Appendix VI

Response to Departmental Comments

A. Response to Departmental Comments on Initial Enquiry on Planning Application Requirement as Submission dated 23 January 2026

B. Response to Departmental Comments on draft S.16 Submission Package as submitted 23 March 2026

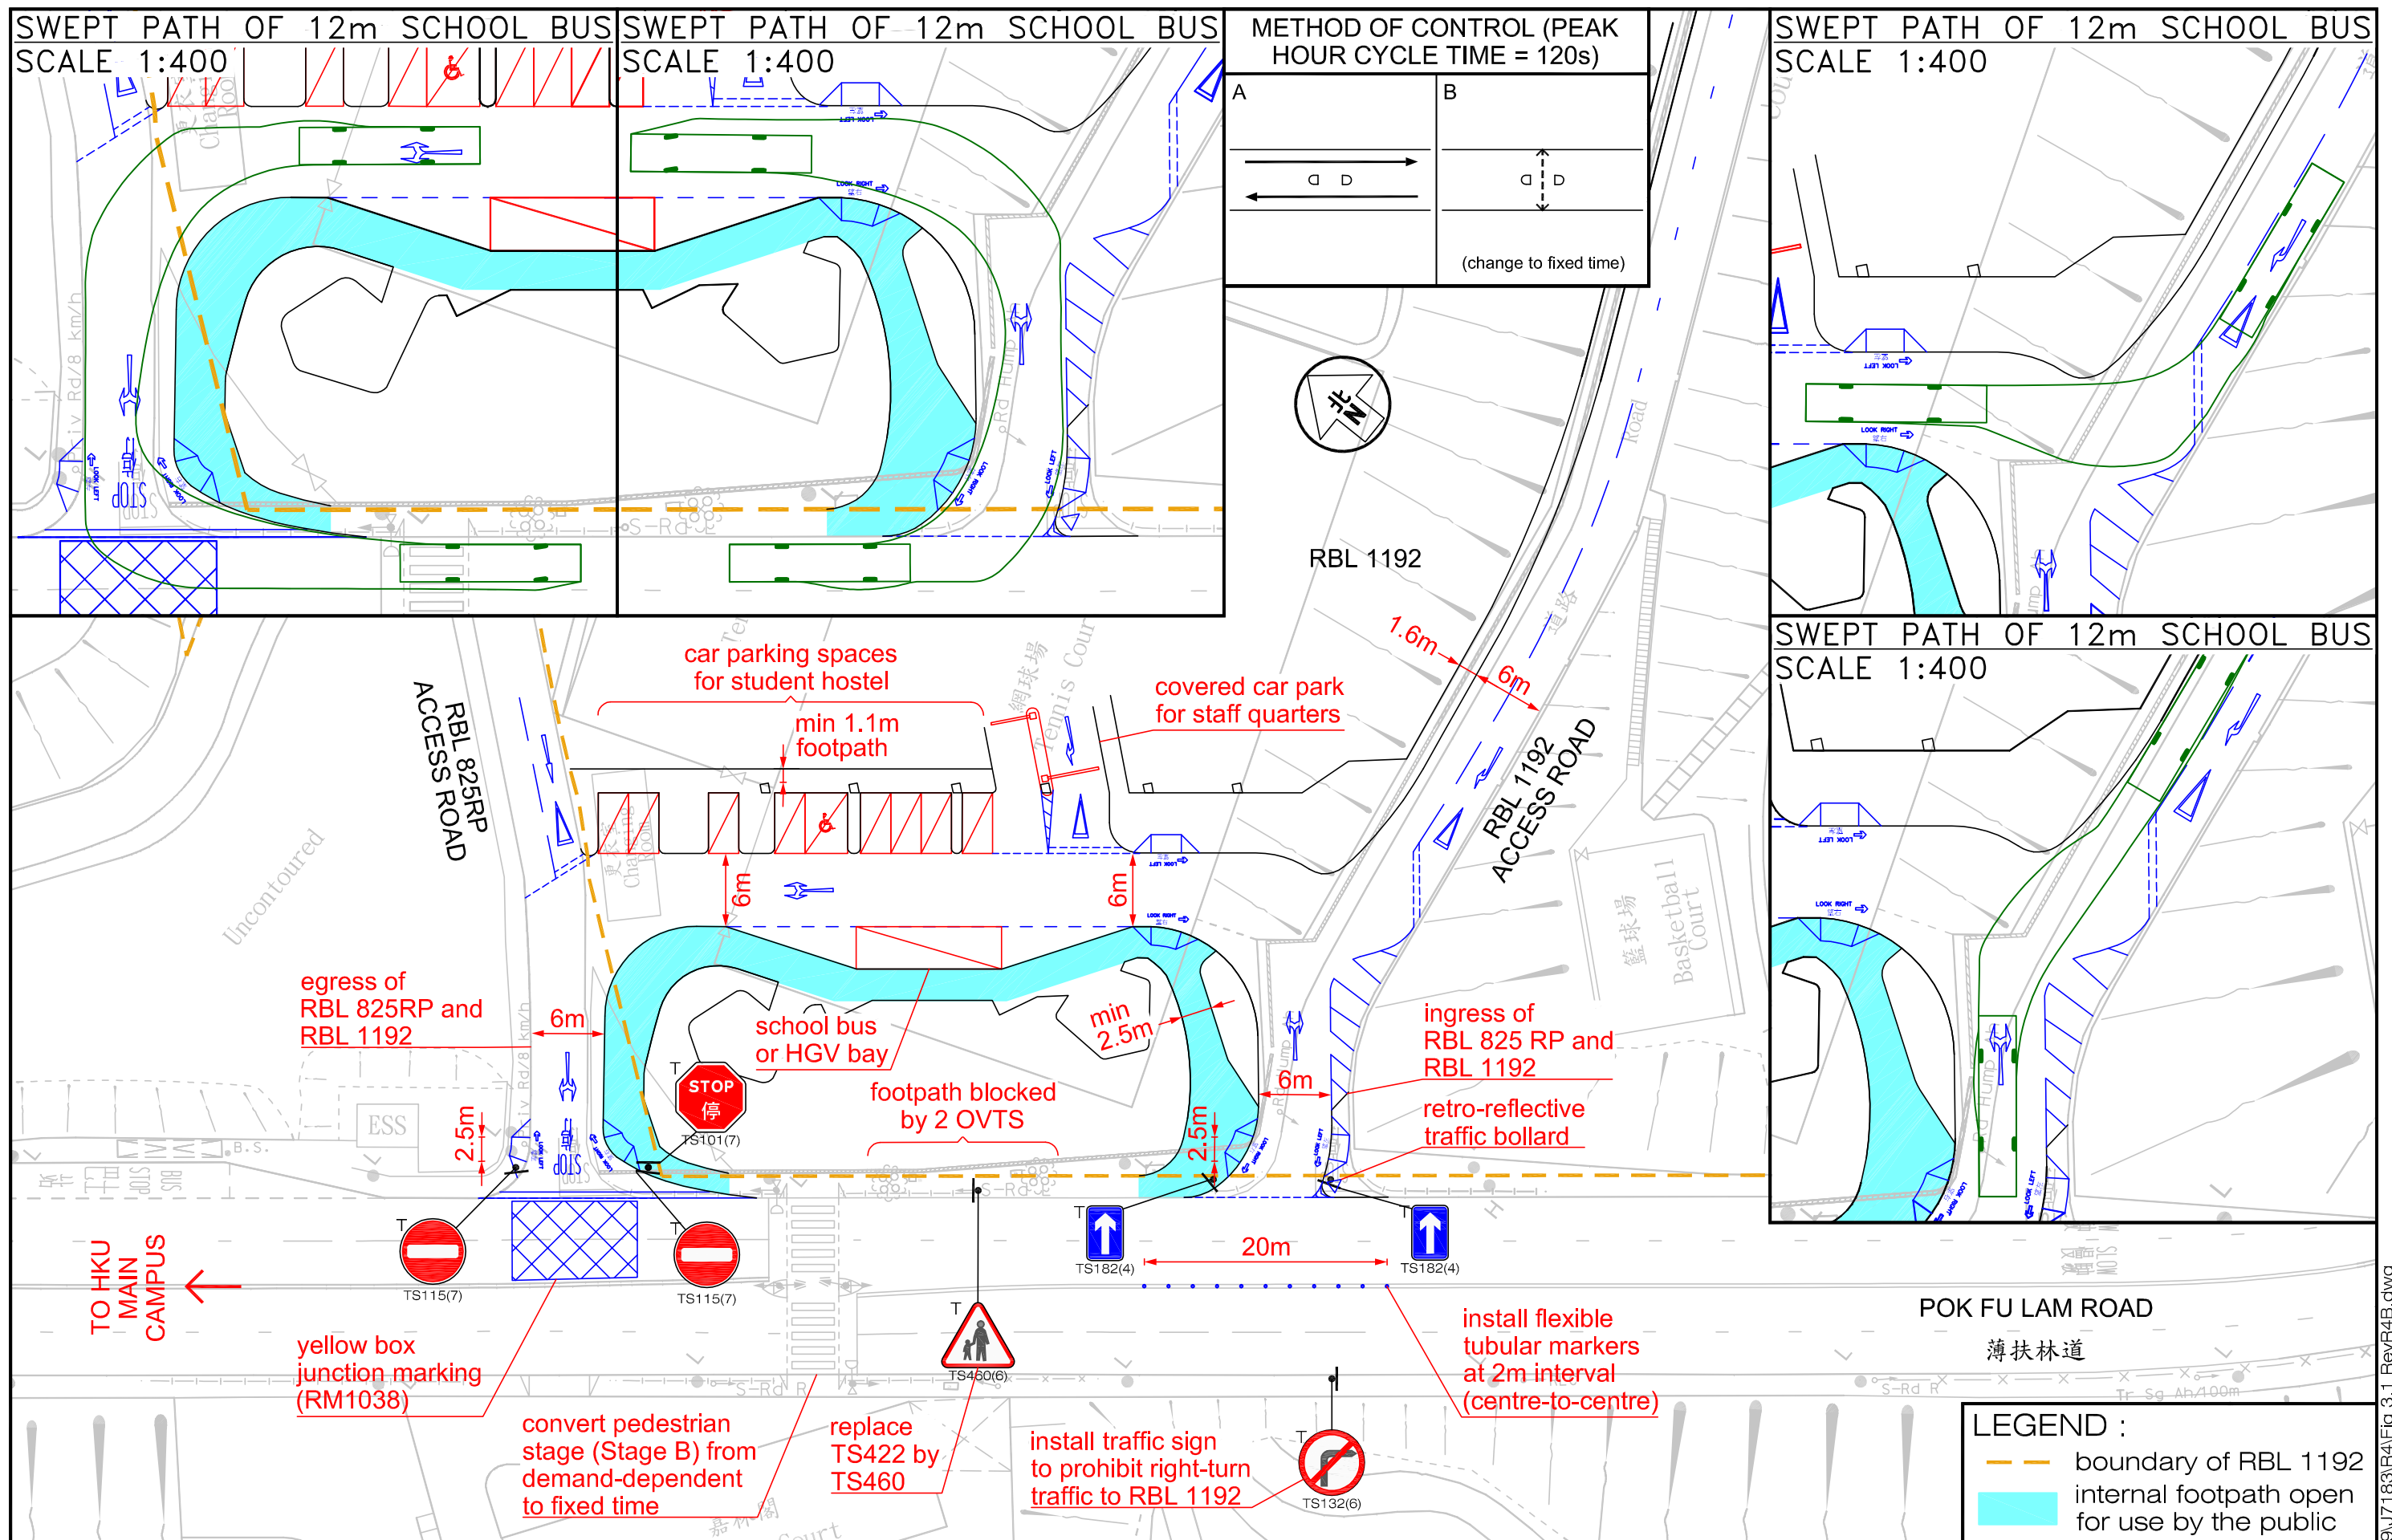
the proposed works will not cause any physical damages to this graded structure	
30.	Commissioner for Transport (Received via email dated 24.4.2026)	<p><u>Vehicular and Pedestrian Access</u></p> <p>(a) Please indicate the width of the two-way access road connecting High West and the proposed development in the Master Layout Plan. According to the swept path analysis in Appendix III, the truck with 11m long would severely encroach onto the opposite lane of the access road. Please consider appropriate traffic improvement measures to resolve the conflict.</p> <p>(b) According to the Master Layout Plan, all pedestrians and vehicles must access the proposed redevelopment via a narrow and steep access road with a footpath on one side. HKU should consider linking the proposed redevelopment to HKU High West to improve the accessibility.</p>	<p>The width of the proposed carriageway connecting to High West is 6m, while the existing access road connecting to Middleton Tower is around 4.5m - 5m. Currently, there are shuttle bus services going up to Middleton Towers via the access road with a footpath on one side.</p> <p>In future operation, traffic flow of heavy vehicle is expected to be small, and therefore the existing access road is considered sufficient. Nevertheless, traffic control management will be implemented to minimize vehicle conflicts.</p>
